# Type N Coupling Nut Change

## Modified Type N Coupling Nut Design

Figure 2. Knurled/Hex Coupling Nut Change

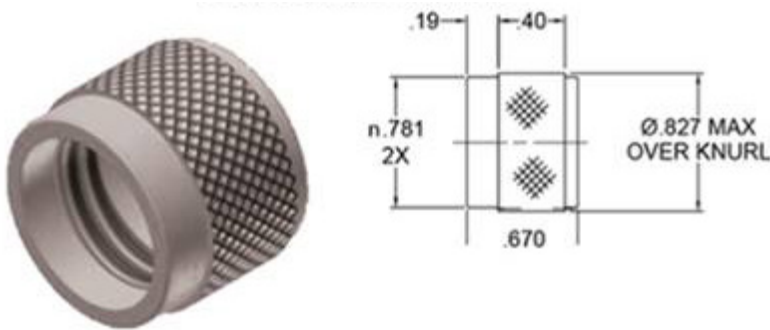
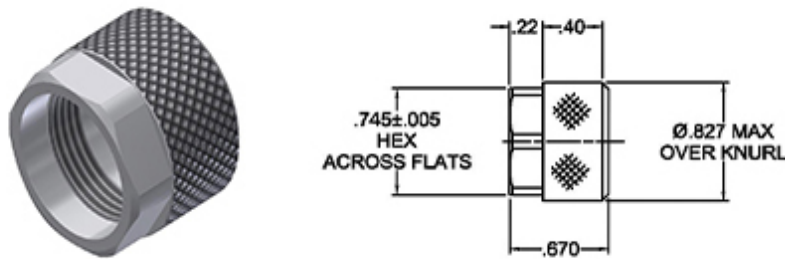
- 3/4" Hex standard, no additional cost  
Previous coupling nut (Figure 1) only had a knurl on a round body.
- Both a Knurl and a 3/4" Hex  
This change ensures that our Type N connectors preserve the exact same form, fit, and function of our previous connector design, but with the added benefit of having 3/4" flats to allow for torquing with a wrench.

- High power and precision test components  
The majority of sales for these components support these applications where proper torque for good connector repeatability is crucial.
